The following is a summary of the updates present in Holley EFI V5 versions Build 100 through Build 160. All of these updates are present in Build 160.

### **V5 Build 160 SOFTWARE AND FIRMWARE UPDATES**

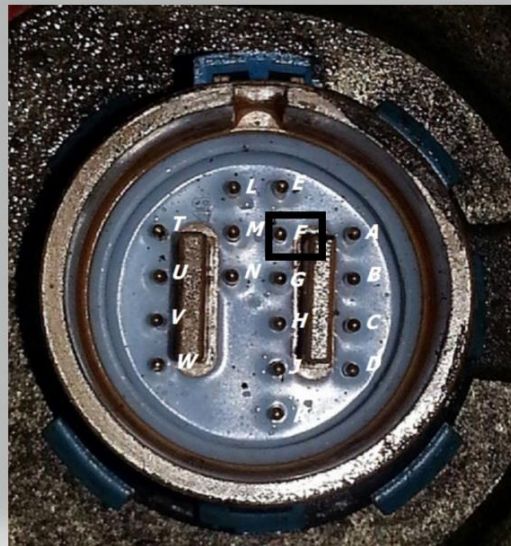
\*\* The “2009+” specifically applies to OEM/factory original applications. When dealing with a GM Performance Parts, reman, or unknown year transmission the transmission connector should be checked per the image below. If pin “F” (shown in the black square below) IS PRESENT, you need the 558-455 harness. If it is NOT present you need the 558-405 harness. Go by THIS PIN ONLY as the other pins may vary transmission to transmission. Be sure you compare your connector to the image below by “clocking” the pins based on the connector slot.
